**COMMISSION OF ARCHITECTURAL REVIEW
STAFF REPORT
April 24, 2018, Meeting**

16. COA-033501-2018 (S. Tuttle)

**815 North 22nd Street
Union Hill Old and Historic District**

**Rehabilitate the existing structure
and construct a 2 story rear addition.**

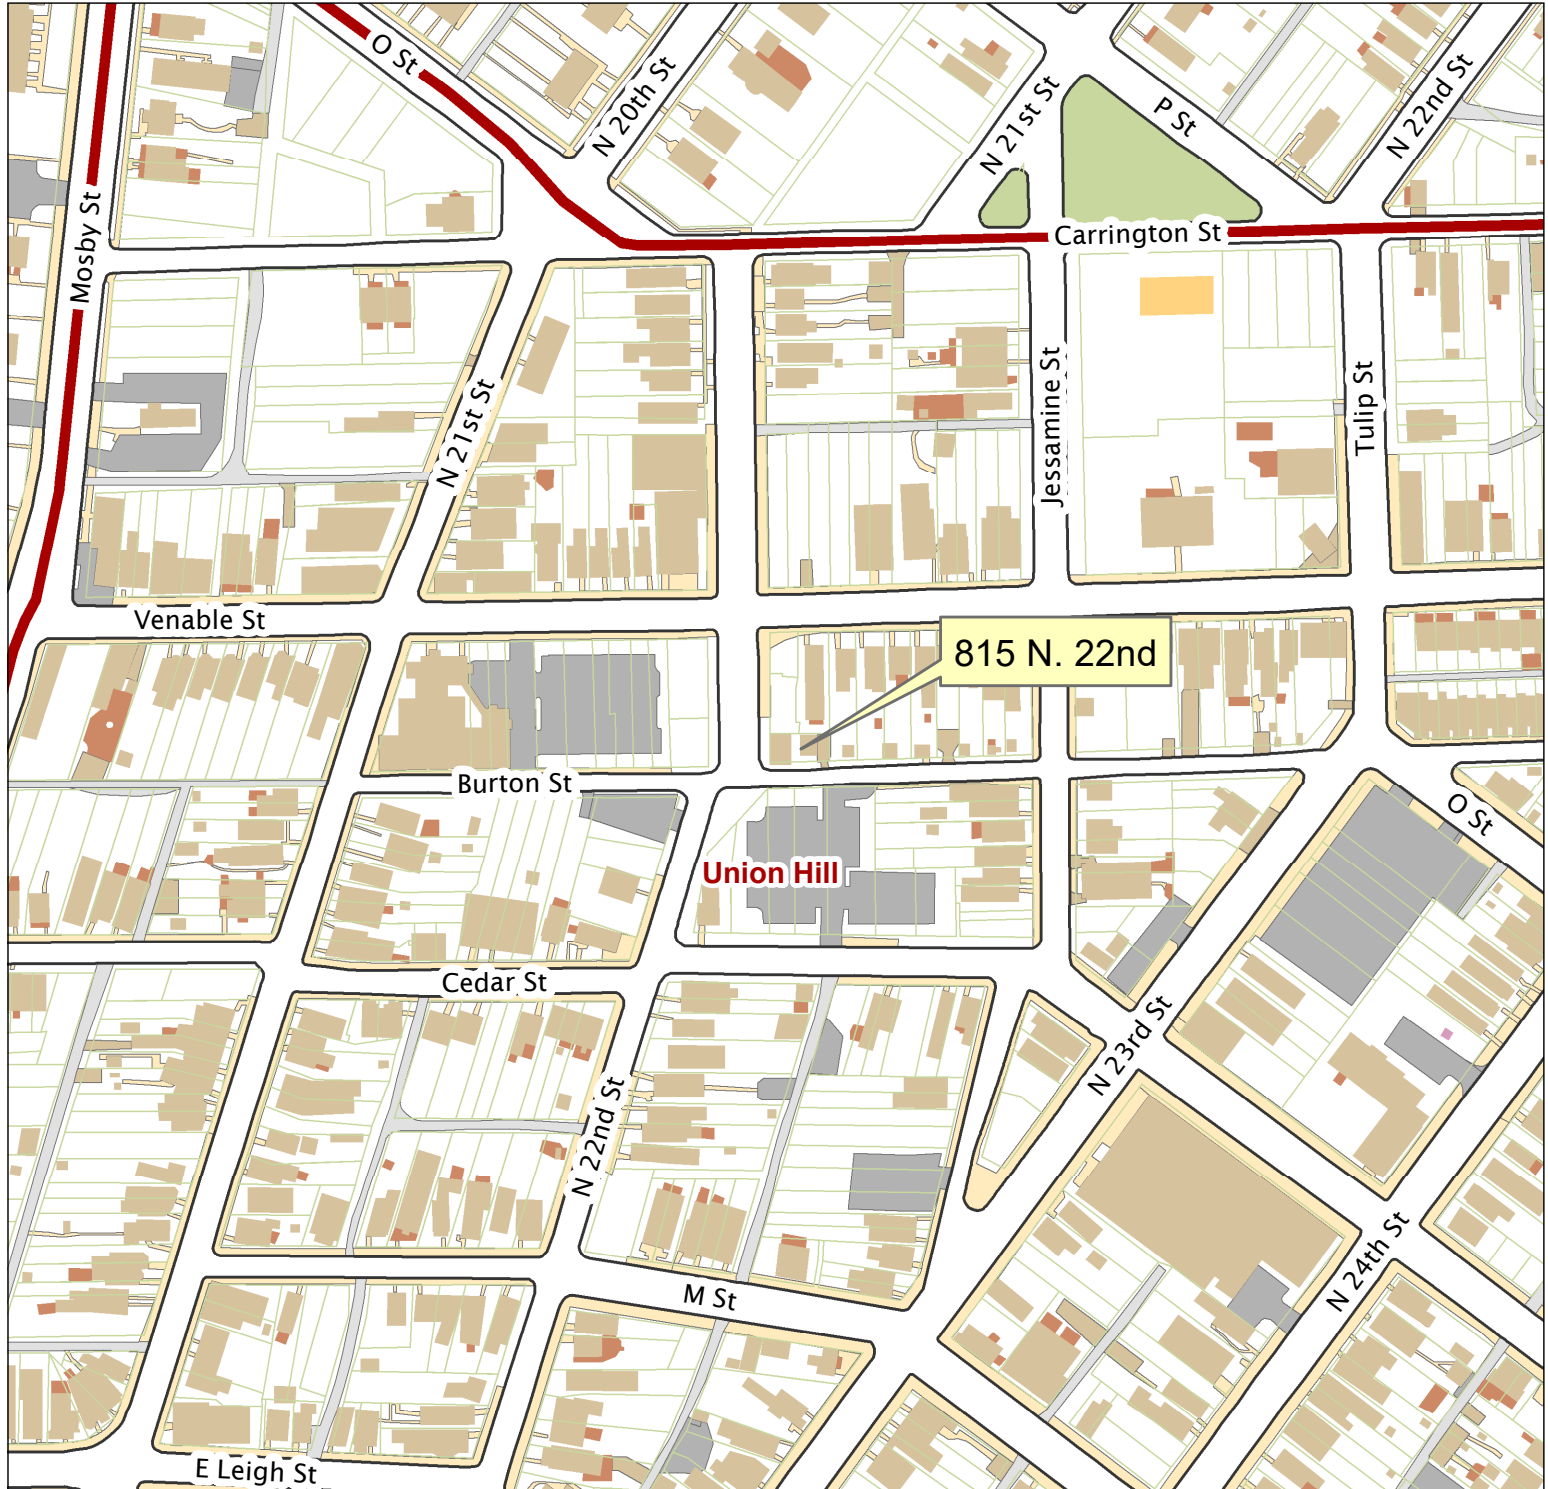
The new addition is similar in form to the existing addition and reflective of the larger addition that once occupied the rear of the property. The addition is spare in detail but offers a three-bay ranked elevation facing Burton Street that is similar to the residential buildings found throughout the district. The rear and north elevation are more contemporary in character.

The proposed project incorporates human-scale elements including vertically ranked windows and a recessed entrance.

Dimensioned elevations were not provided but the addition is shown in context with the historic building and is of a similar height.

The proposed addition is similar in width to the adjacent houses and maintains the 3-bay, vertical alignment, and symmetry of the surrounding buildings.

The typical fenestration pattern in the district includes evenly spaced ranked windows. The proposed Burton Street elevation is consistent with patterns in the district. The window pattern on the rear and north side of the addition is very simple with aligned window heads.

The proposed frame construction is consistent with new and historic structures in the District. No material specifications were provided.

The following items will need to be included for final review (please refer to the Commission's New Construction Checklist and Required Dimensions document for additional details):

1. Dimensioned floor plans, elevations, and site plan
2. List of windows and doors, including size, material and design
3. List of materials and finishes
4. Dimensioned site plan
5. Context plan and elevations
